<b>Topic</b>	Convertible roof – revised clip arrangement - C flap Bowden cable (SC13/12)
<b>Market area</b>	Worldwide Bentley (1WBE)
<b>Brand</b>	Bentley
<b>Transaction No.</b>	2033508/1
<b>Campaign number</b>	E788
<b>Note</b>	
<b>Type</b>	
<b>US code</b>

E788

Convertible roof – revised clip arrangement - C flap Bowden cable (SC13/12)

Figure 1

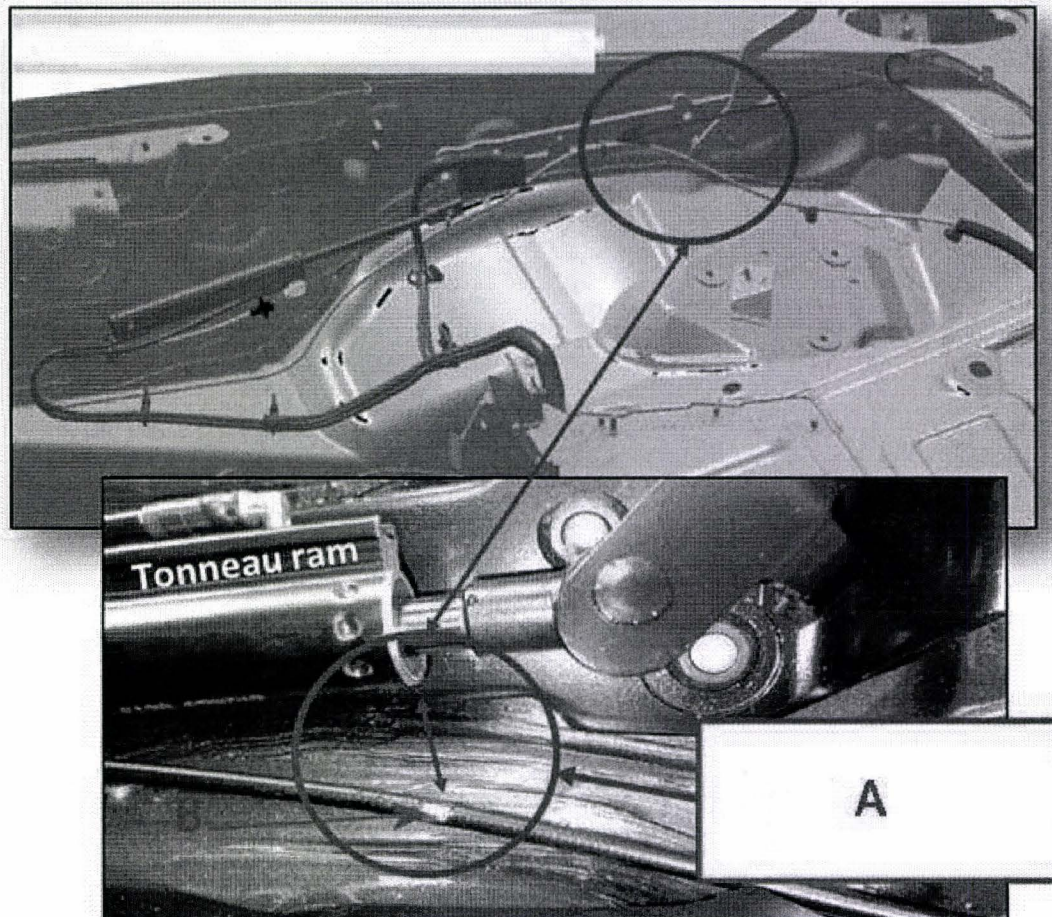
A potential compression point has been identified between the tonneau cover hydraulic ram and the C flap Bowden cable as it routes under the tonneau cover drive system (see Figure 1). A revised clip arrangement has been specified to avoid this compression damage. In severe cases the damage to the Bowden cable is such as to impair correct operation of the C flap, therefore a test of the C flap function is required to ensure the Bowden cables are serviceable before implementing the revised clip arrangement

- Figure 1 details the original routing and single cable tie (C) securing the Bowden cable (shown in yellow). The detail at point A shows the potential contact point between the tonneau cover hydraulic ram and the Bowden cable. The actual contact takes place when the tonneau is almost closed and therefore the close proximity of the hydraulic ram and the Bowden cable cannot be seen when viewed with the tonneau cover in a transient position. Detail B shows, in this case, a section of the outer sheath of the Bowden cable that has been removed by repeated contact with the ram.

Note: as long as the system has passed the C flap function test then the absence of some of the outer sheathe is not sufficient grounds to change the cables

Figure 1

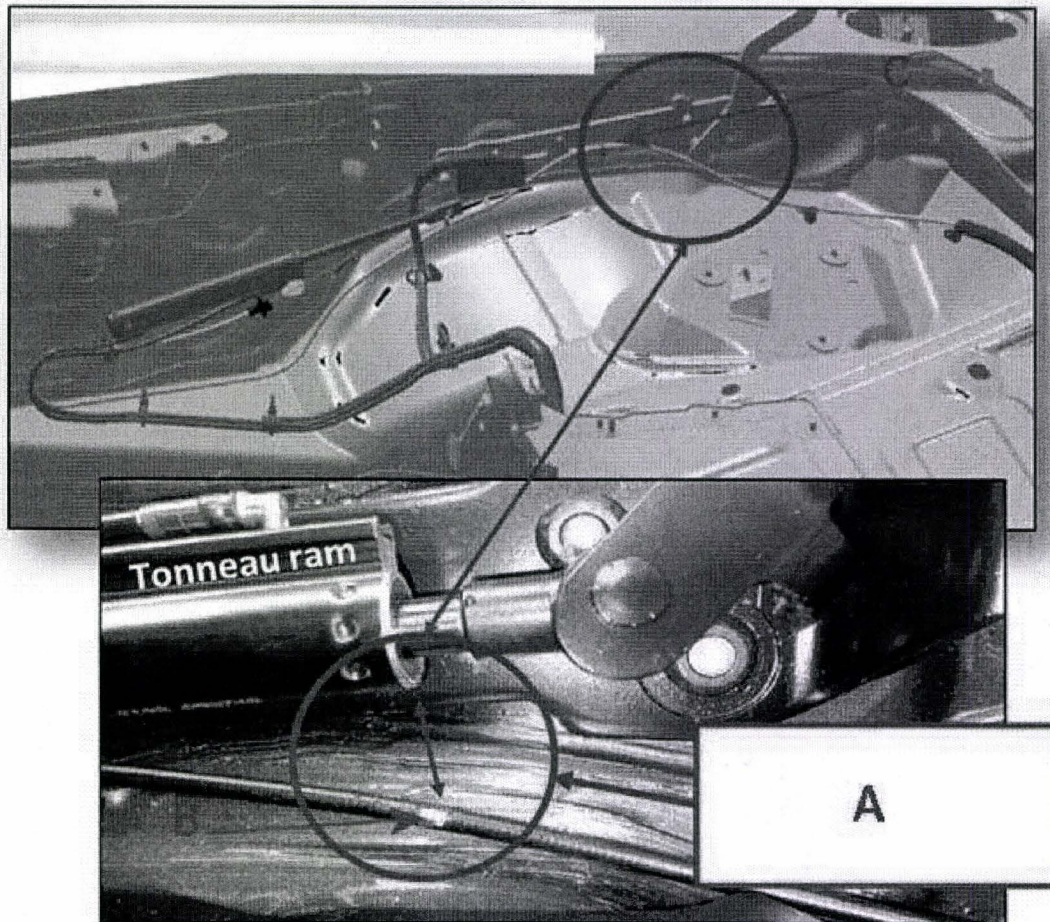
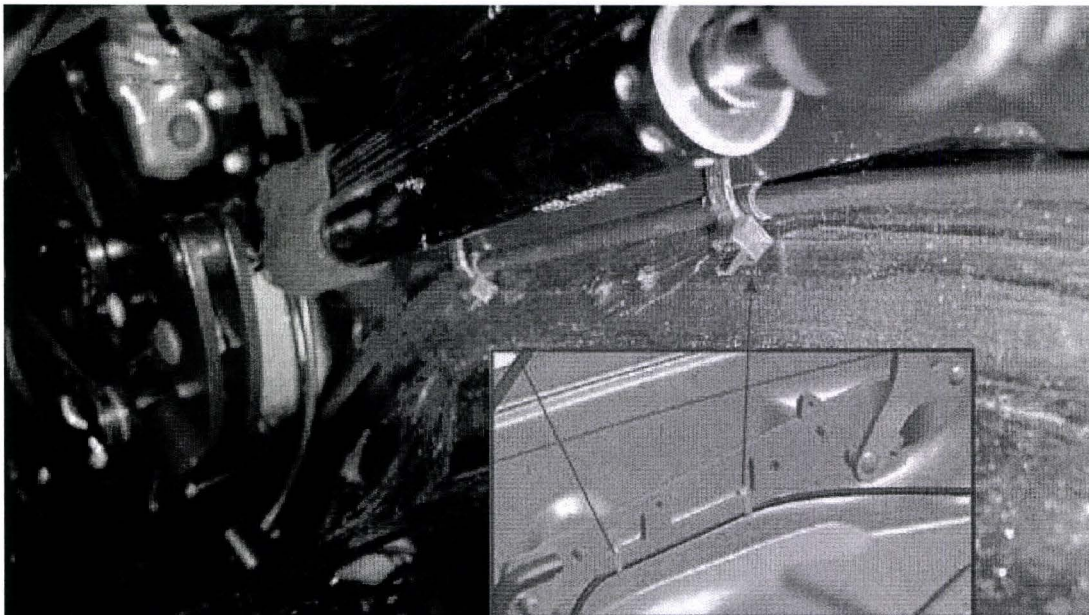
A potential compression point has been identified between the tonneau cover hydraulic ram and the C flap Bowden cable as it routes under the tonneau cover drive system (see Figure 1). A revised clip arrangement has been specified to avoid this compression damage. In severe cases the damage to the Bowden cable is such as to impair correct operation of the C flap, therefore a test of the C flap function is required to ensure the Bowden cables are serviceable before implementing the revised clip arrangement

1. Figure 1 details the original routing and single cable tie (C) securing the Bowden cable (shown in yellow). The detail at point A shows the potential contact point between the tonneau cover hydraulic ram and the Bowden cable. The actual contact takes place when the tonneau is almost closed and therefore the close proximity of the hydraulic ram and the Bowden cable cannot be seen when viewed with the tonneau cover in a transient position. Detail B shows, in this case, a section of the outer sheath of the Bowden cable that has been removed by repeated contact with the ram. Note: as long as the system has passed the C flap function test then the absence of some of the outer sheath is not sufficient grounds to change the cables

6. With the tonneau cover still held in the vertical position, support the tension bow with a suitable prop taking care not to damage any trim (see figure 6)
7. Remove the original cable tie securing the Bowden cable (C) to the tonneau cover drive system (see Figure 1)

8. Referencing figure 7 secure the Bowden cable to the tonneau cover drive system using two cable ties. Ensure the Bowden cable is retained underneath, along the bottom of the bracket, where it cannot come into contact with the hydraulic ram. It may be necessary to temporarily release the Bowden cable from other retaining clips to gain sufficient length to enable the two new cable ties to be attached.

Figure 3

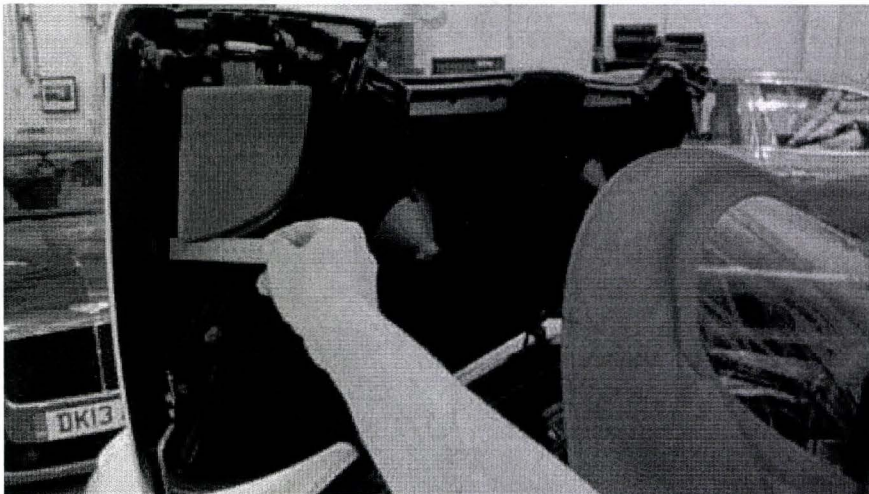
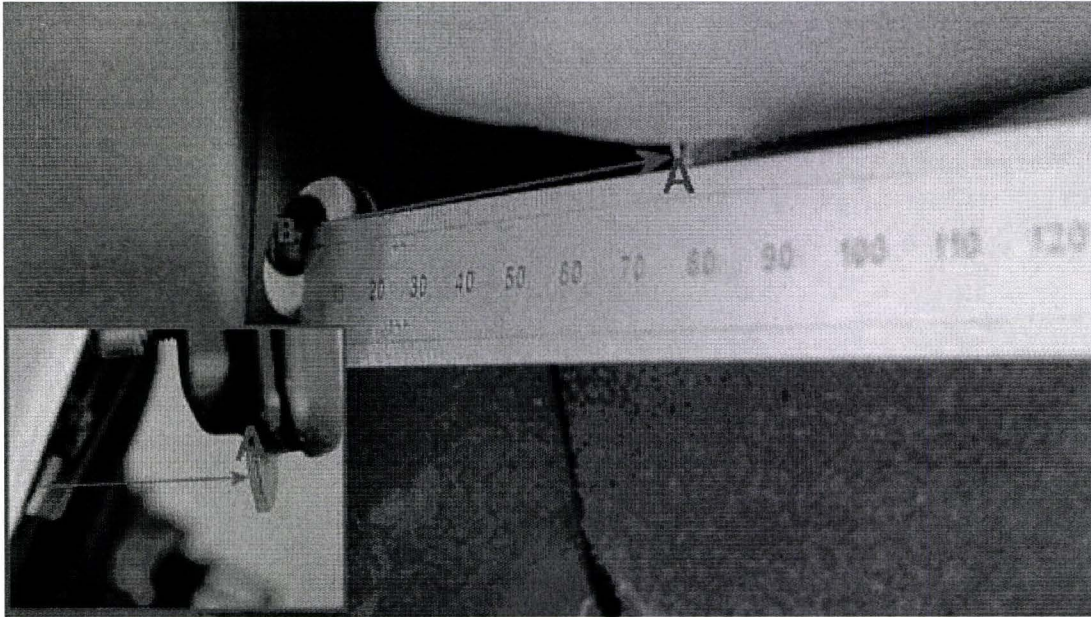
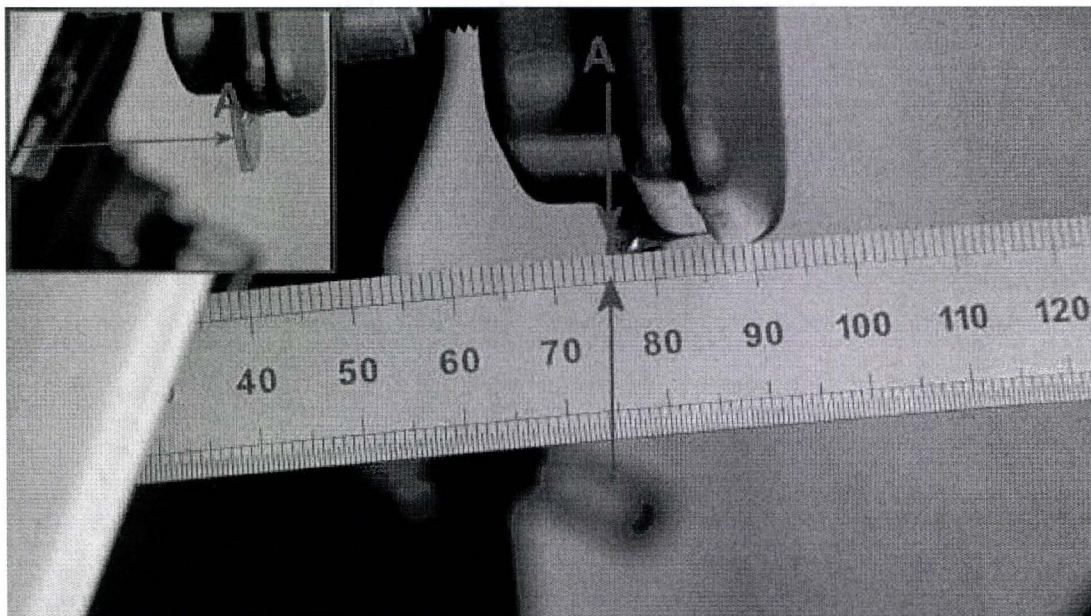
5. Referencing figures 3, 4 and 5 take a measurement between point (A), C flap obscuration lip, and (B), tonneau brightware securing bolt head. The correct specification for this measurement is 74mm to 90mm. If this measurement is not to specification or the C flaps are out of synchronisation or judder during operation then refer to TPI 2033467 to carry out C flap Bowden cable replacement. If the C flap is to specification then perform the revised clip arrangement
